EMAIL REGARDING U S NAVY RESPONSES TO U S EPA REGION VI COMMENTS ON SITE  
5 FIELD TASK MODIFICATION REPORT WITH ATTACHMENTS NAS CECIL FIELD FL  
3/21/2012  
NAVFAC SOUTHEAST

**NAS Cecil Field**

**OU2, Site 5**

**Response to EPA Comments on the Site 5 Field Task Modification Request form, FTMR 03**

**SAP Worksheet #5 -- Project Organizational Chart**

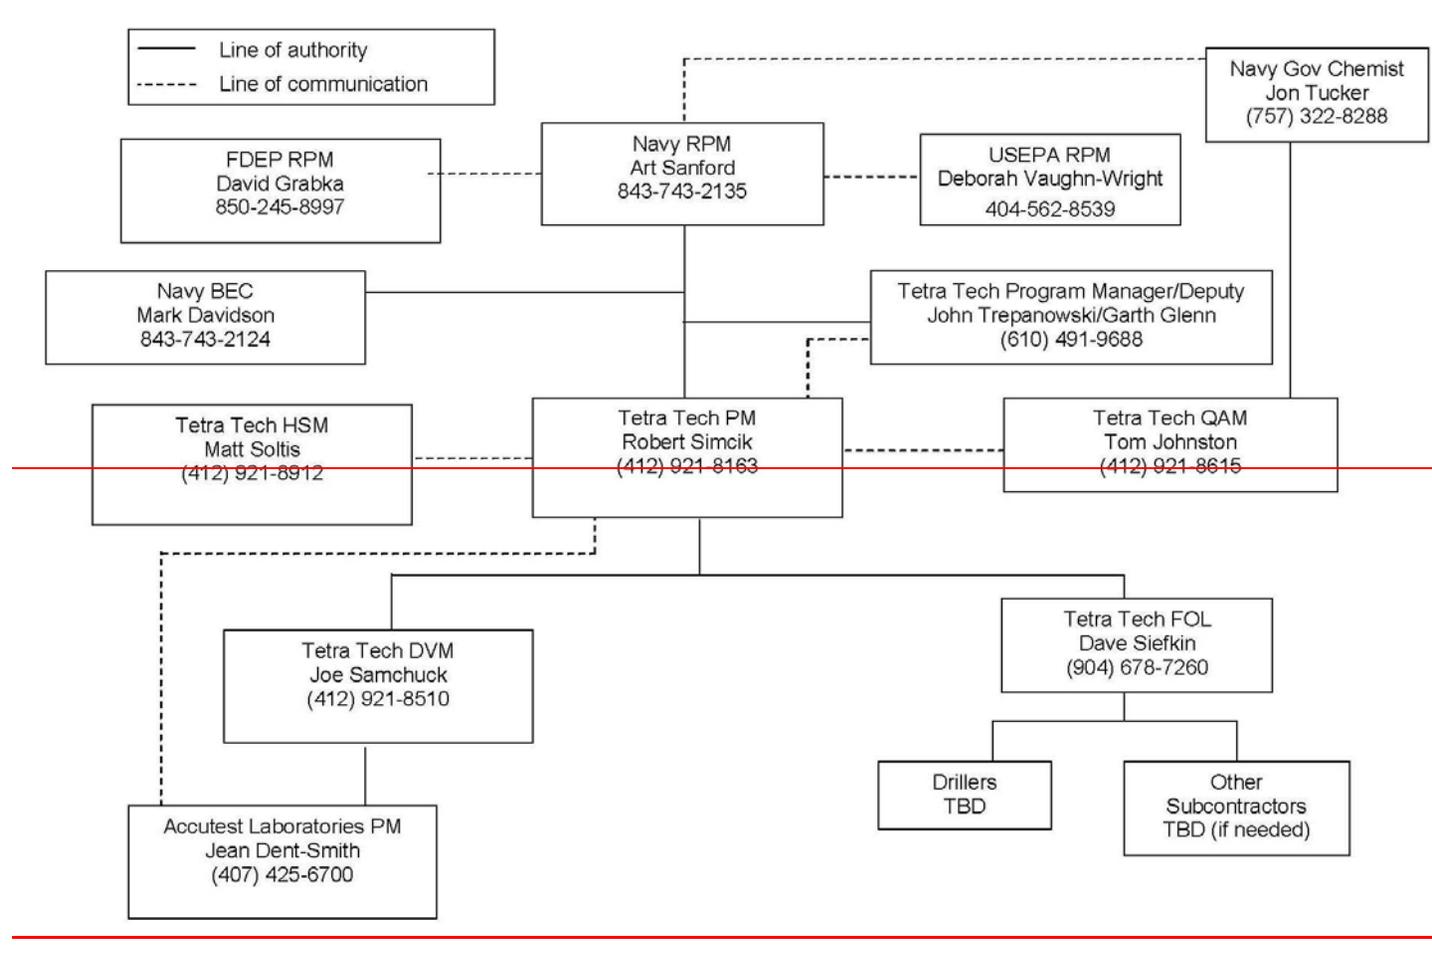
**Comment 1: Worksheet #5: Recommend adding Stacin Martin.**

Response to Comment 1: Stacin will be added as recommended.

CONTRACT NUMBER 2267	
APPROVED BY	DATE
APPROVED BY	DATE
DRAWING NO. FIGURE 2	REV 0

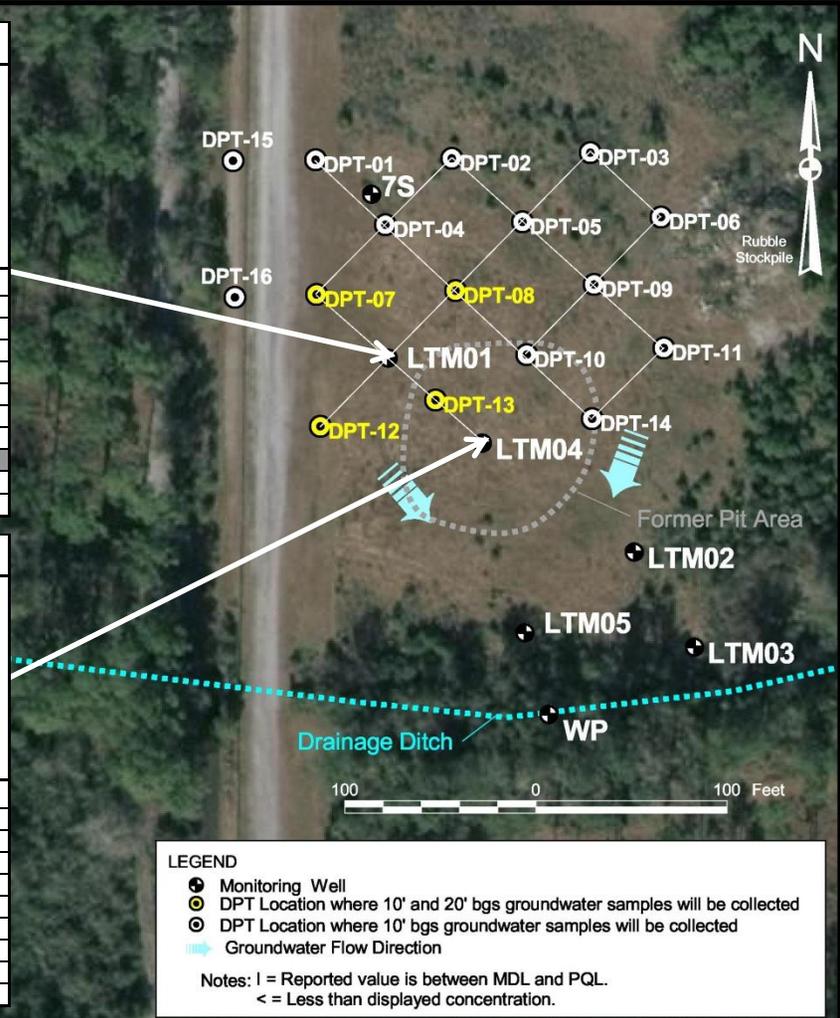
**Comment 10: Figure 2: was the area to the west of site 5 investigated during the original RI? Recommend placing a DPT across the road.**

Response to Comment 10: This will be added as recommended, and the number of total DPT samples will be updated accordingly throughout the FTMR. Two additional locations will be added.
